1997 - 2002 Corvette: Service Bulletin: SMU - Revised Side Cover and Gasket Replacement (RH)/Differential Carrier Cover and Seal Replacement

Number: 02-04-20-003

Date: 07-18-2002

Subject: SMU - Revised Side Cover and Gasket Replacement (RH)/Differential Carrier Cover and Seal Replacement - Right

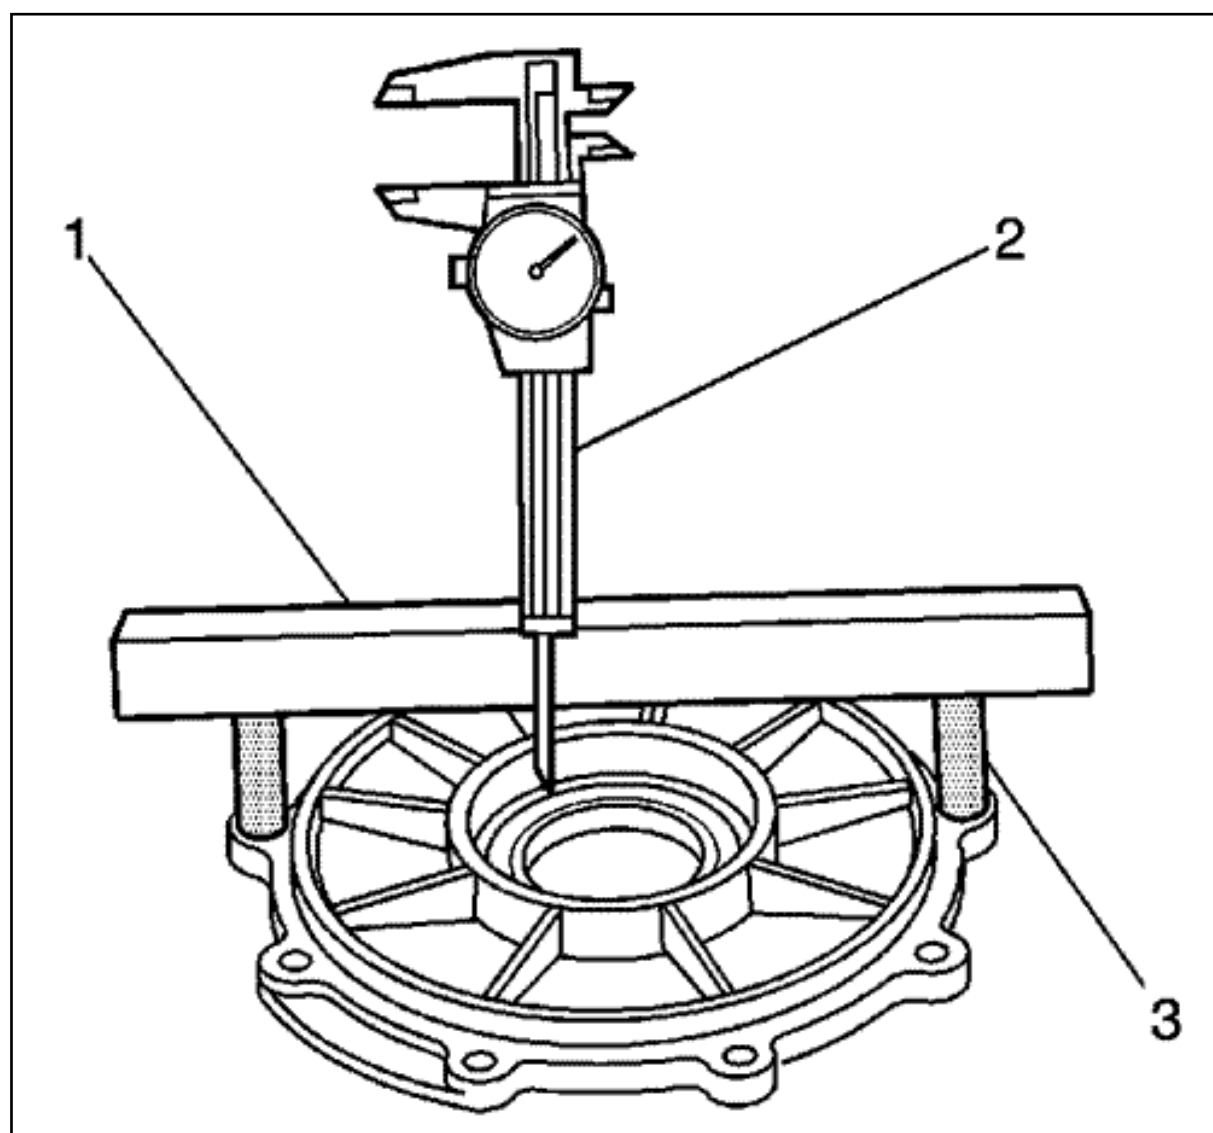
12. Using a hydraulic press, remove the bearing race (1) and shims (2). Mark or tag the shims for assembly.

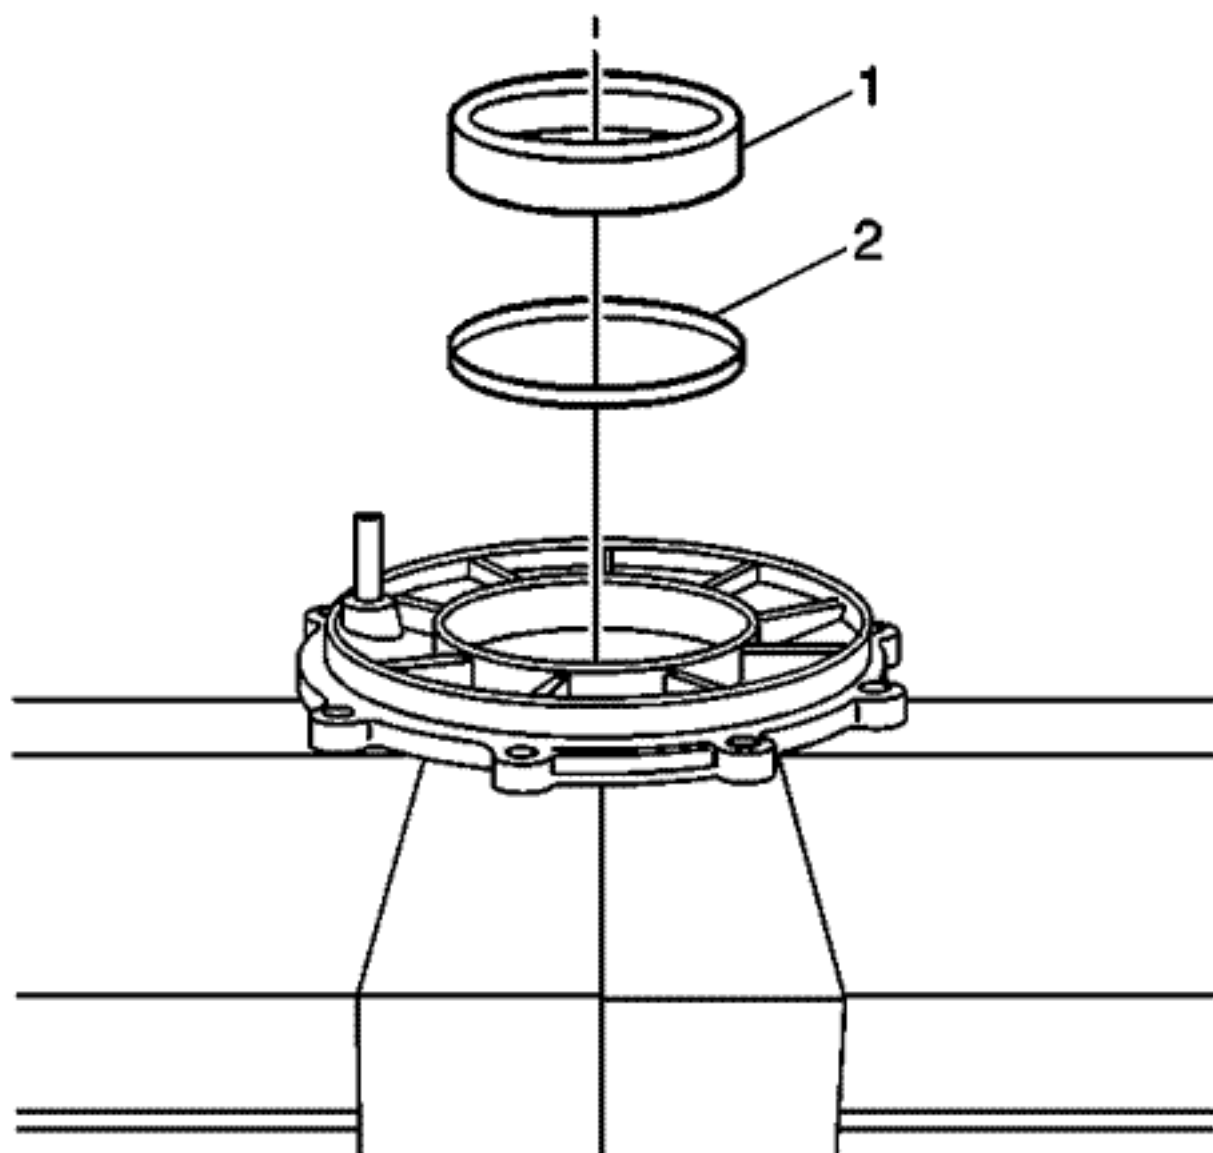
Whenever service requires the replacement of the right side differential cover, the covers **MUST be measured and the right side shim pack adjusted to compensate for machining tolerances between the two components. Failure to perform this measurement procedure may result in improper differential bearing preload.**

13. Use a caliper (2), a straight edge (1), and J 42168-16 (3) in order to measure the NEW differential cover bore dimension. Record the measurement as value A.
14. Use a caliper (2), a straight edge (1), and J 42168-16 (3) in order to measure the old differential cover bore dimension. Record the measurement as value B.
15. Subtract value B from value A. If the computation is a positive value, add shims equal to the value, to the existing shim pack. If the computation is a negative value, subtract shims equal to the value, from the existing shim pack.

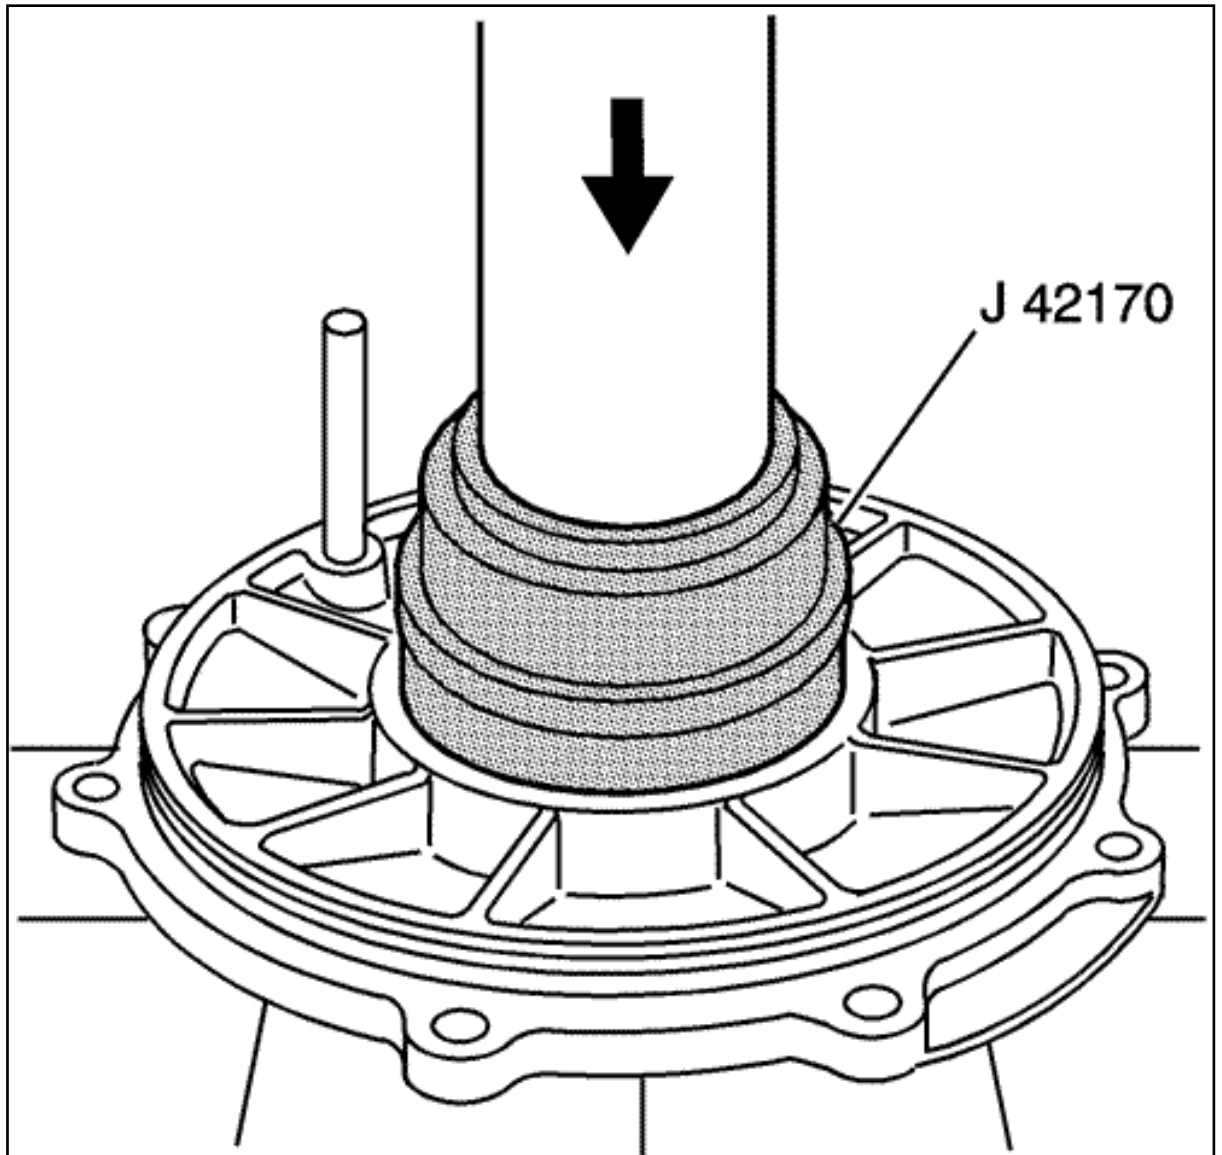
1. Install the selected shims (2) and the bearing race (1) to the NEW cover (right).

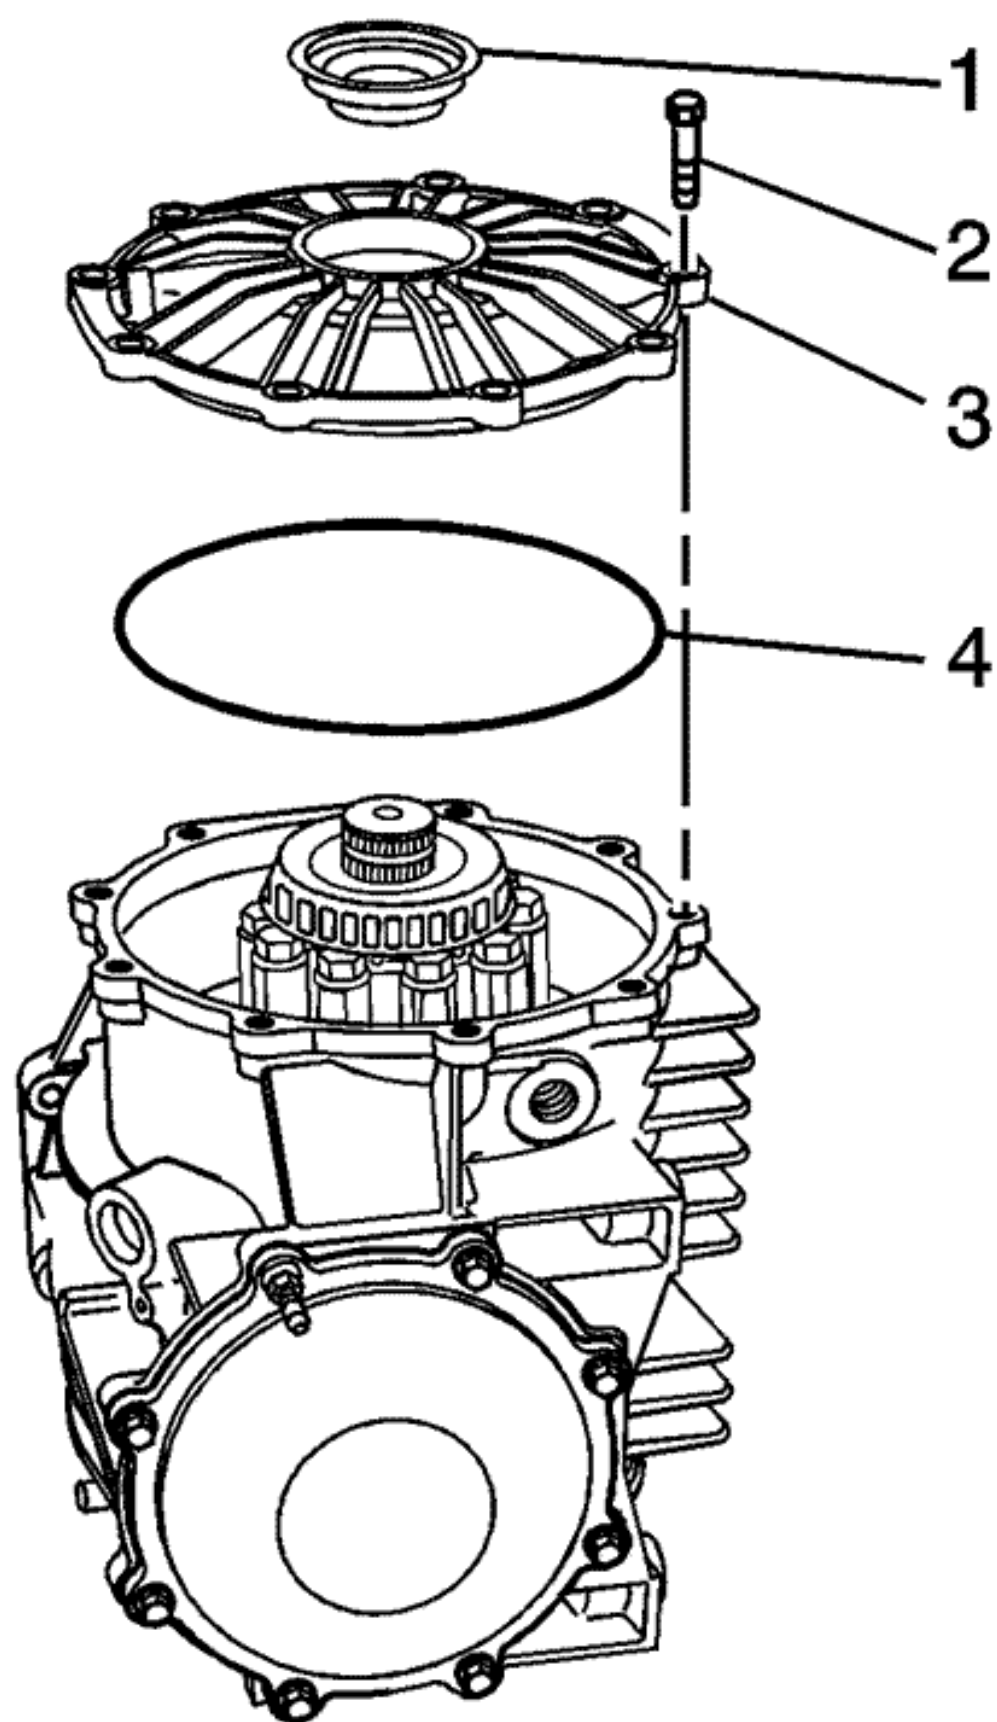
2. Press the shims and bearing race into the NEW cover (right) using the J 42170 and a hydraulic press.
